INTERIM AMENDMENT
TO
FEDERAL SPECIFICATION

KNIVES; GENERAL PURPOSE SHOP, DETACHABLE BLADE

The General Services Administration has authorized the use of this interim amendment as a valid exception to Federal Specification GGC-K-494B, dated April 10, 1974.

FIGURE 3. Standard blade.

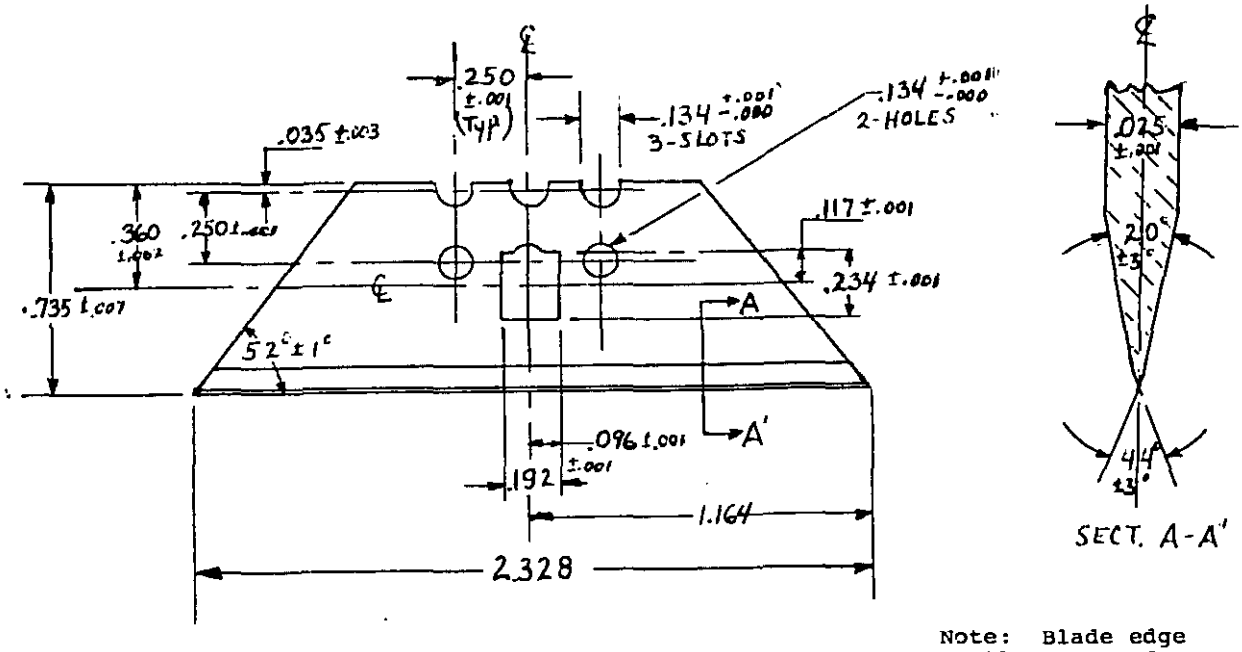
3.6 Blades. The blades shall be of high carbon steel conforming to QQ-S-700 steel number SAE 1095. The blades shall be hardened, tempered, and ground. The Rockwell hardness of the blades shall be not less than the equivalent of 50 nor more than 64 on the C scale when tested as specified in 4.5.2. Five blades shall be furnished with each knife, and these (5) plus all replacement blades shall conform to the standard configuration and dimensions of figure 3.

Note: Unless otherwise specified, tolerances ±.005 inch.

Note: Blade edge shall be ground smooth and sharp.
